CITY OF MINNETRISTA

CITY COUNCIL BUSINESS ITEM

Subject: Application for a preliminary plat with the proposed name of North Pointe at Halsted Bay and a rezoning to Planned Unit Development of the properties located at 6710 Halstead Avenue, 6750 Halstead Avenue, 6701 County Road 110W, and 36 Address Unassigned; R-2 – Low Medium-Density Single-Family Residence Zoning District.

Meeting Date: August 4, 2025

REVISIONS:
1. 4/7/25 City of Minnetrista Comments
2. 5/22/25 Revised Lot Layout
3. 6/18/25 Revised Outlot B, Block 1 and 2 Lots
4. 6/30/25 Revised Lots 1-4, Block 4, and Plot Name Change

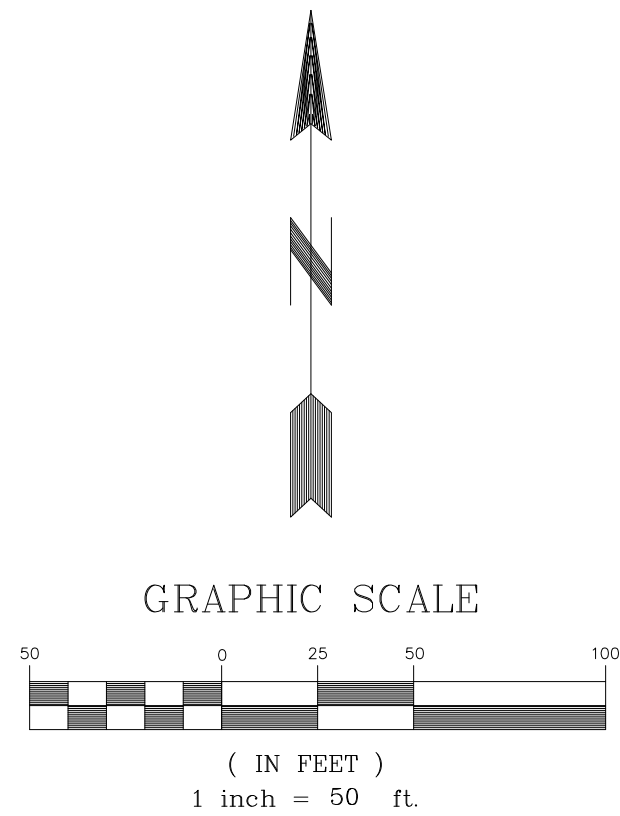
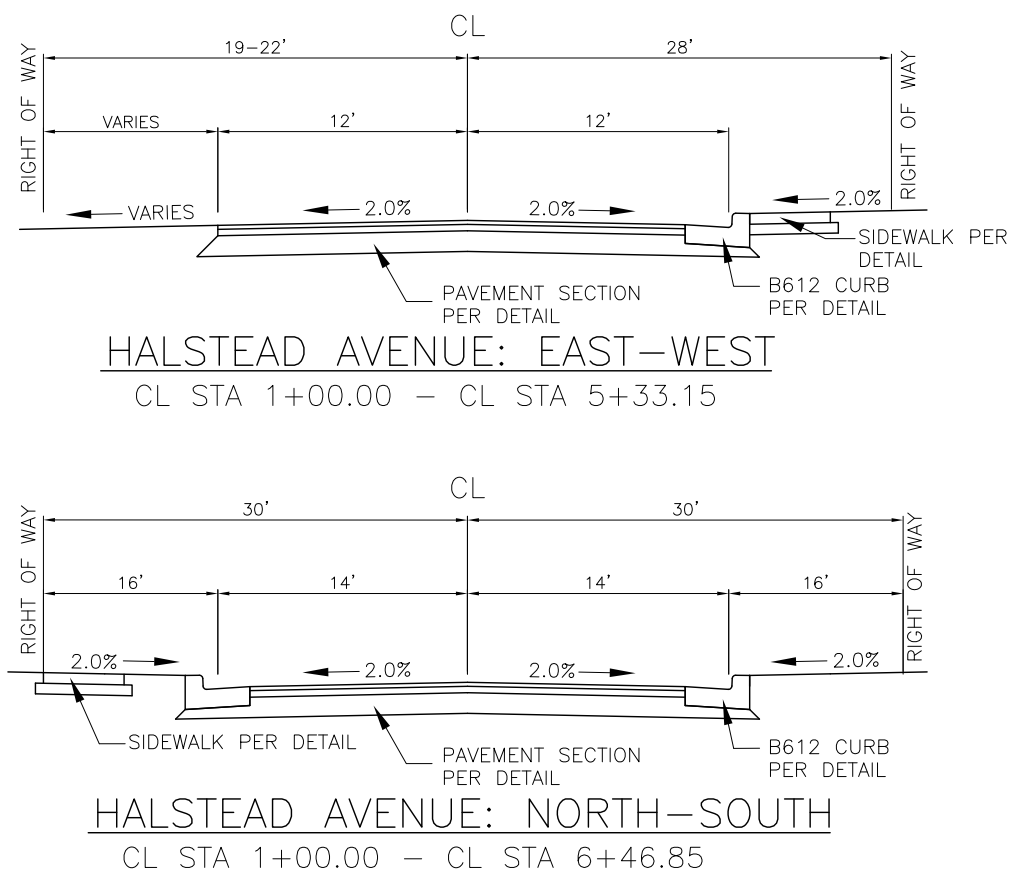
1. *City code requires the private road to be in an outlet that's 50' wide- currently it's shown at ~25'. This comment has been addressed.*
2. The final plat must include a drainage and utility easement that extends minimum of 10' on each side of a public utility. Based on the current layout this comment applies to Lots 2 and 3 Block 1 (sanitary sewer) and Lot 7 Block 2 (storm sewer).

This comment is modified as follows: The final plat must include a drainage and utility easement that extends minimum of 10' on each side of a public utility. Based on the current layout this comment applies to Lot 7, Block 1 (storm sewer). Show the drainage and utility easements on the utility plan in order to confirm that adequate easements are proposed for the utilities in Blocks 2 and 3.

GRADING & EROSION
CONTROL PLAN

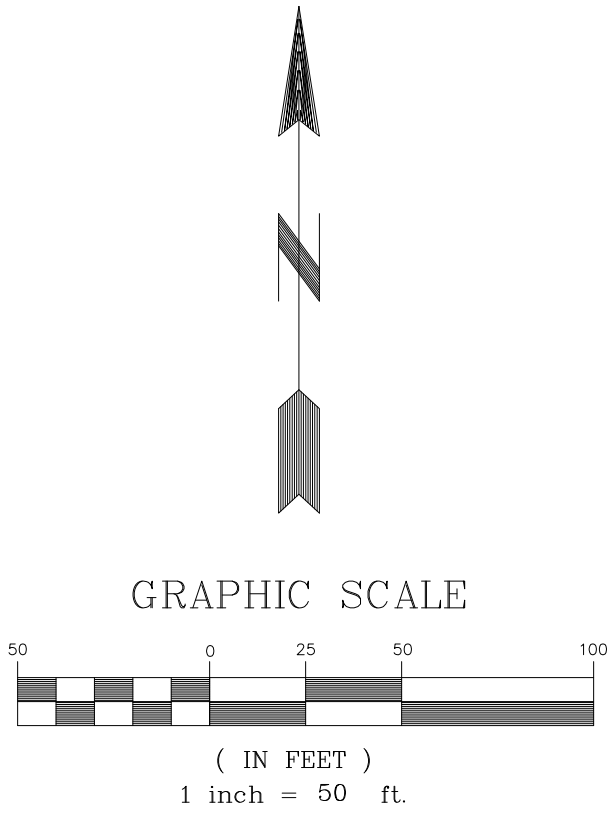
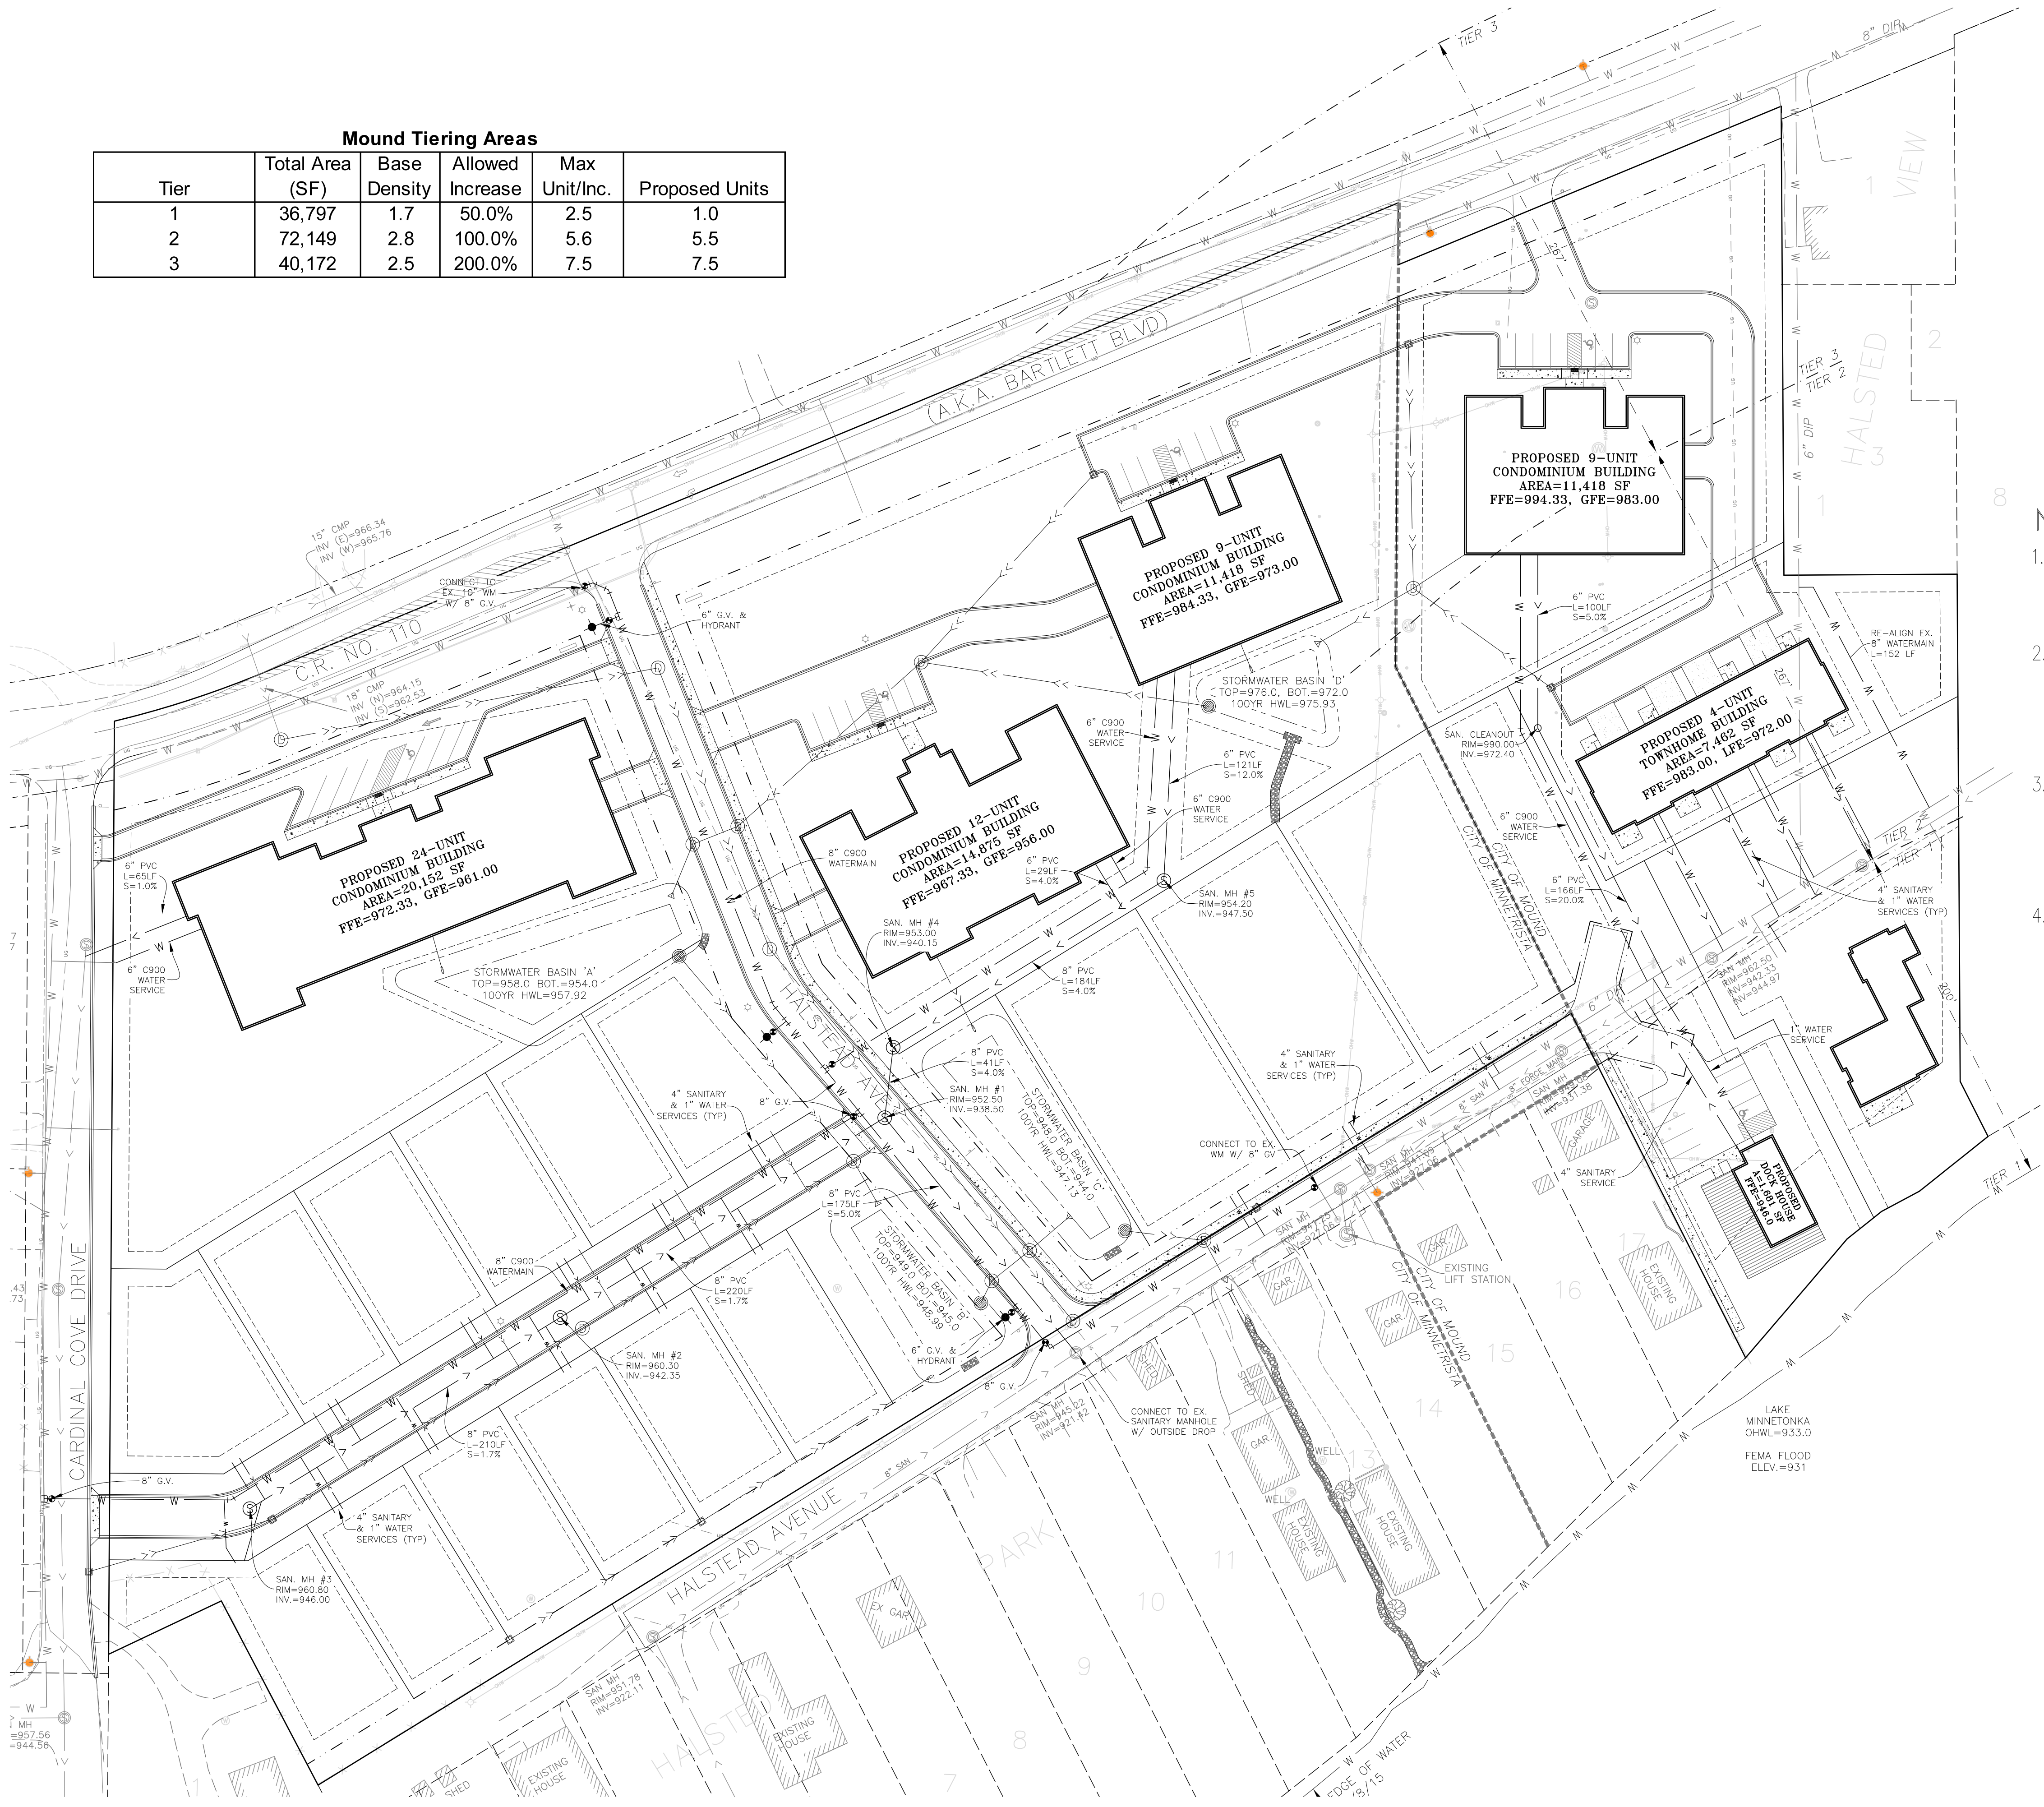
1. *The proposed low-floor elevations need to be shown to determine if there's a conflict with the high-water elevations and emergency overflow elevations. This is of particular concern for Lots 4 -6, Block 2 and Lots 2 -4, Block 3. **This comment has been addressed.***

2. *Note the NWL and HWL of the stormwater basins on the plan. If these correspond to the "top" and "bot." elevations shown on the plan, then the elevations shown for "Stormwater Basin B" are incorrect. **This comment has been addressed.***

3. *The existing contours on Lot 6 Block 2 are not shown correctly: the 952 contour extends to the north and bisects the 953, 954 and 955 contours. **This comment has not been addressed.***
